DA2025/0077

DA SUBMISSION – 10-28 LAWRENCE STREET, FRESHWATER

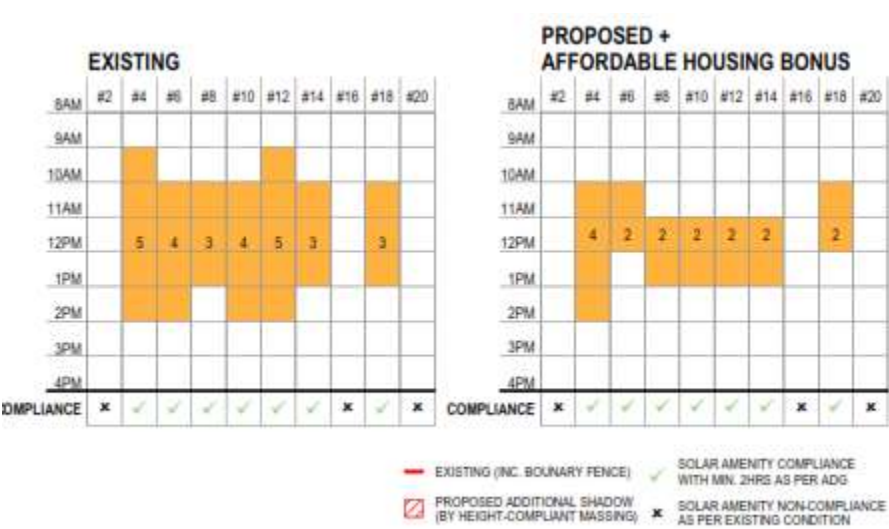
3. Lack of sufficient retail parking

The Warringah DCP requires 72 retail parking spaces.

The development provides 62 spaces, 10 spaces short.

The submitted traffic report provides no reasonable argument for the shortfall in parking provided. Parking in Freshwater is very difficult, and the lack of sufficient parking will place further stress on the availability of street parking which will impact on parking for local residents. Providing additional retail GFA without sufficient parking is contrary to the provisions of the DCP and will impact on public parking in the area.

- Reduction in building height to comply with the maximum height permitted
- Increase setbacks to the southern boundary to comply with ADG separation requirements
- Provide an additional 10 retail parking spaces
- Amend the building envelope to ensure all dwellings to the south retain a minimum of 3 hours solar access between 9am to 3pm as per Clause D6 of Warringah DCP
